Safety Evaluation Report

related to the operation of
Vogtle Electric Generating Plant,
Units 1 and 2

Docket Nos. 50-424 and 50-425

Georgia Power Company, et al.

Figure 3.1 Structural model of typical fuel rack

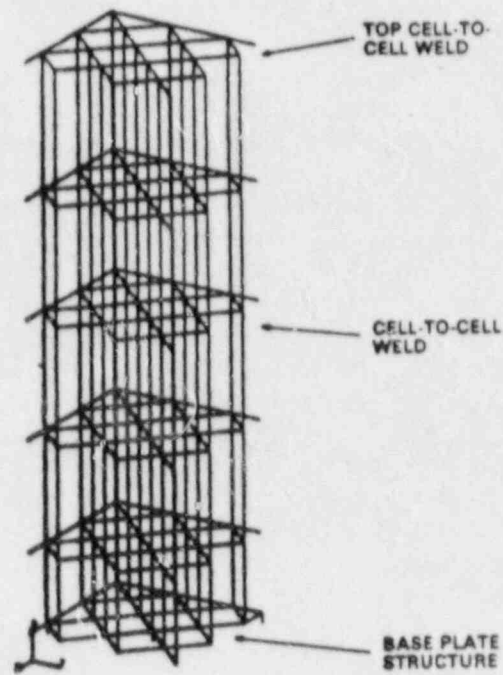
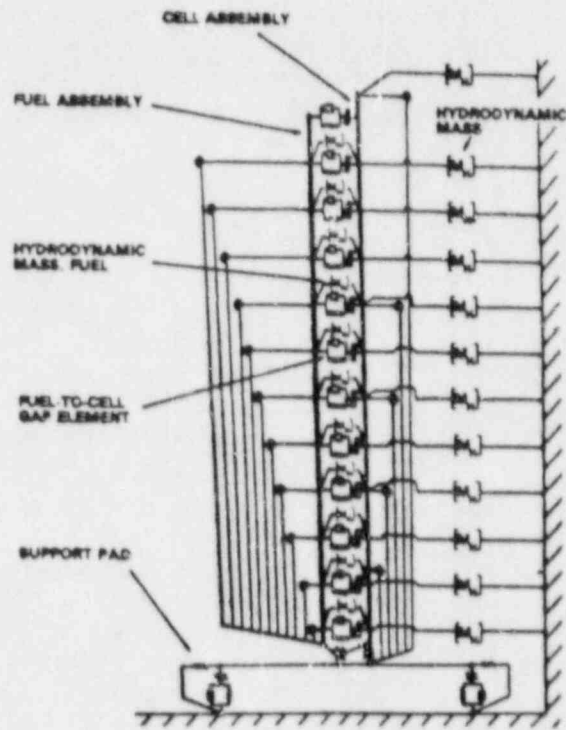
The licensee has provided analysis results of stresses due to the interactions between the rack and pool floor and between the fuel and cell within a rack for both operating basis earthquake (OBE) and SSE conditions. The results indicated that the maximum stresses in the liner plate and concrete floor are less than allowable stress values for the rack and pool floor interaction and that the maximum acceleration on the fuel assembly was 3.0 g. In response to the staff request as to what g levels the fuel assembly had been qualified for, the licensee stated in the submittal of July 20, 1987, that the actual maximum test load was 20 g. Therefore, the integrity of the fuel assembly will be maintained during earthquakes.

The licensee has calculated the maximum thermal stress in the rack as 4000 psi by assuming that one cell was loaded with hot fuel while the surrounding cells remained empty. When this maximum thermal stress combined with stresses associated with seismic and dead weight, the licensee stated that the total stress was still below the allowable stress value. Therefore, the integrity of the rack will be maintained during thermal and seismic conditions. During a July 15, 1987, telephone conference call, the staff questioned the validity of using 25% of critical damping for the fuel grid and asked for documentation. The licensee responded in the July 20, 1987, submittal that the grid damping value of 25% had been developed from data presented in Westinghouse document WCAP-9401-P-A, which was approved by the staff by letter dated May 7, 1981. The staff considers that the damping question has been answered and resolved.

Figure 5.1 Vogtle low-pressure safety-injection system normal ECCS alignment

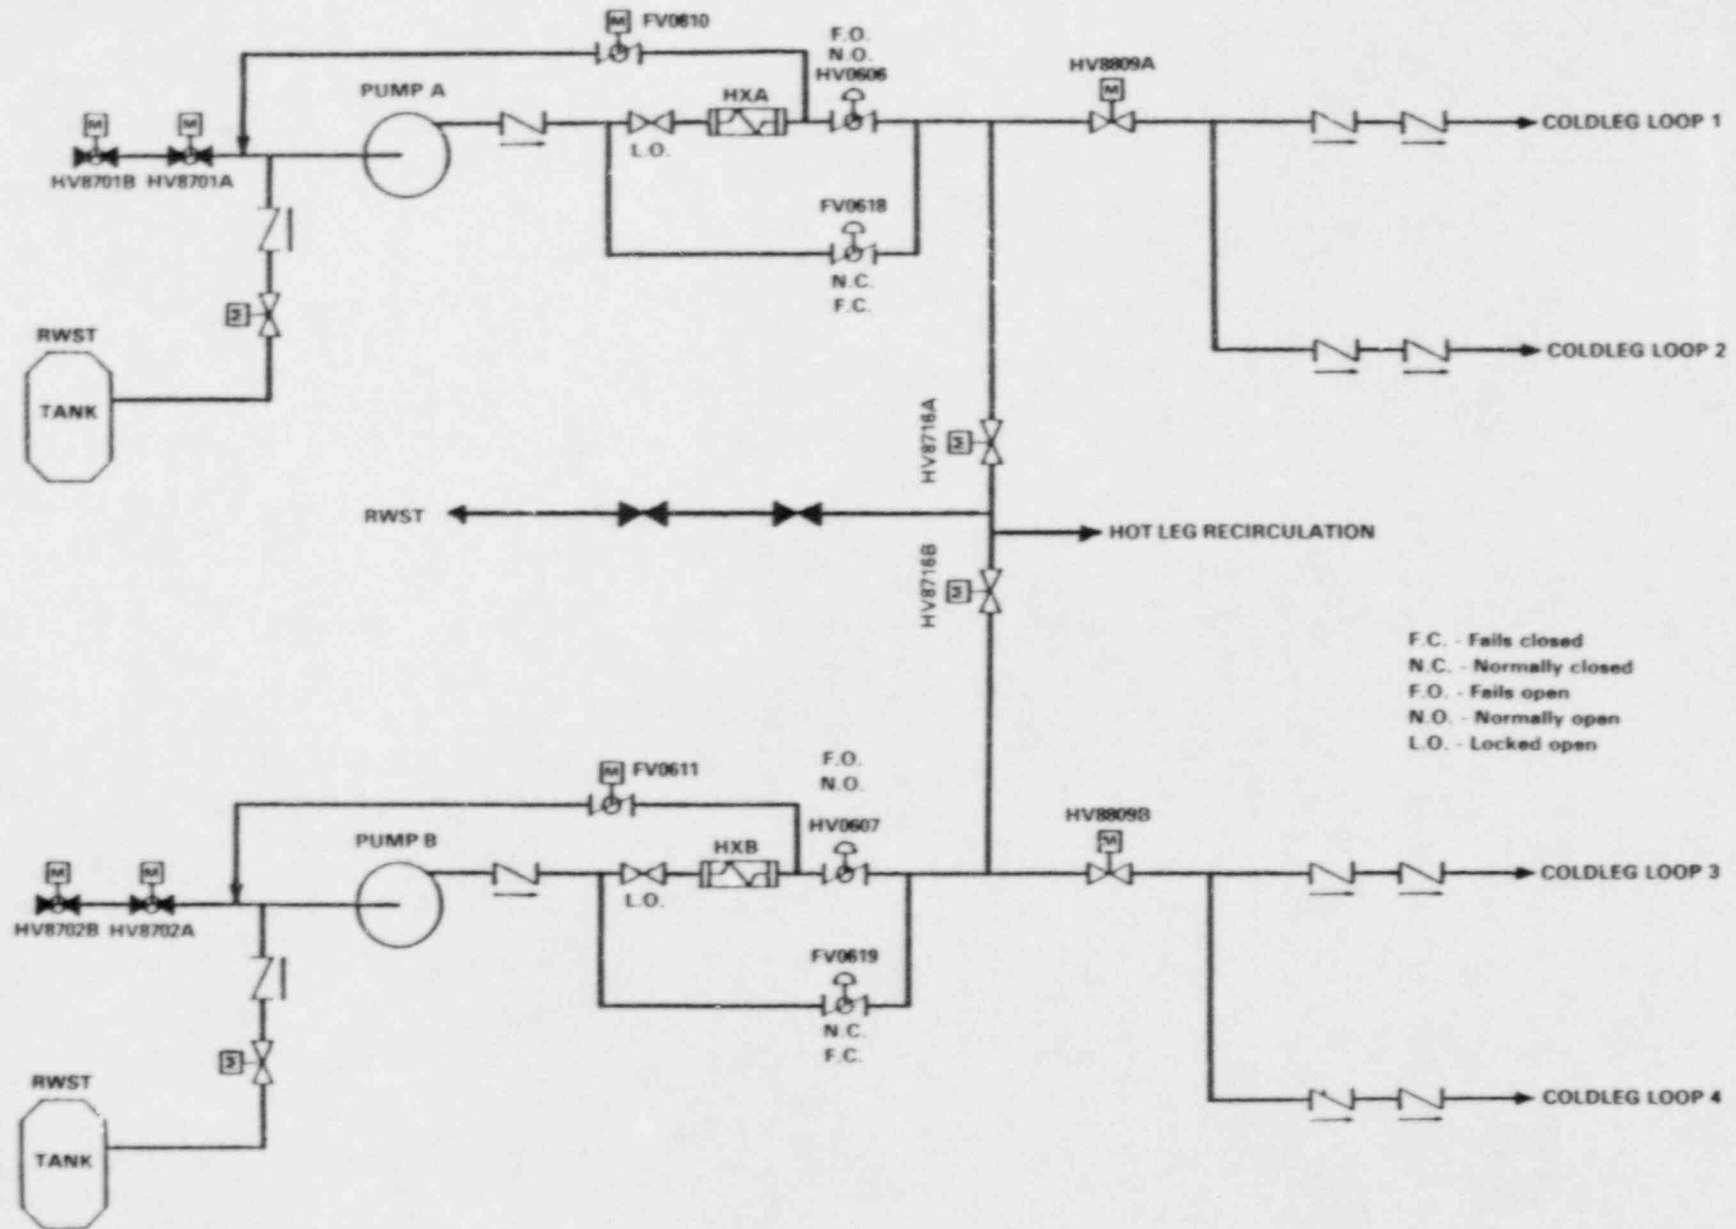
In its October 27, 1987, letter, the licensee described two surveillances which would require closure of valves 1HV-8716A and B. These valves are required to operate following a loss-of-coolant accident (LOCA) in order to allow initiation of hot-leg recirculation, and therefore, stroke testing of these valves at power allows detection of any valve degradation. For stroke testing, the valves would be individually closed for approximately three minutes every 90 days. In other respects, the configuration would be the same as that shown in Figure 5.1. During surveillance, additional single failures are not required to be assumed. Therefore, flow would continue to be available from two RHR pumps into all four RCS cold legs. This configuration has no impact on the capability of the RHR system to perform its function.

The licensee has also committed to revise its IST Program to reflect its intent regarding RHR pump testing and thereby withdraw its cold shutdown justification associated with valves 1HV-8716A and B. The staff requires that the IST revision be submitted in a timely manner.

The licensee has shown, and the staff agrees, that based on analysis, closure of one of the valves in question would not render the RHR system inoperable. Rather, the minimum ECCS flow requirement would continue to be met. Therefore, the licensee can perform the surveillances discussed above in accordance with the current Technical Specification (TS) 5.2 without requiring any TS modification. However, the licensee is required to include a discussion of the supporting analysis for LOCA in Mode 3 in the next FSAR amendment.
